APPLICATION FOR SOIL INVESTIGATION

Metrolina North Mobile Home Park,
Lot No. 4 E

SITE EVALUATION

Re: Property located at Henderson Circle North, Lot 4-E

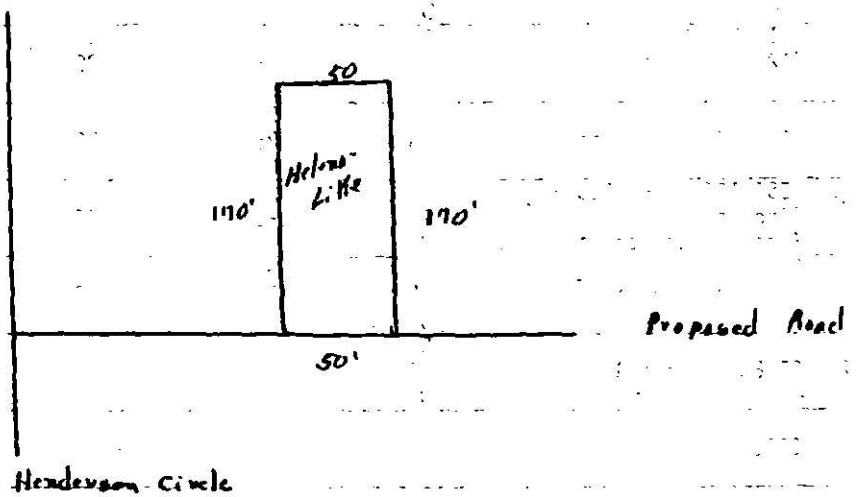
9. SITE CLASSIFICATION: unsuitable

Recommendations/Comments: lot size inadequate
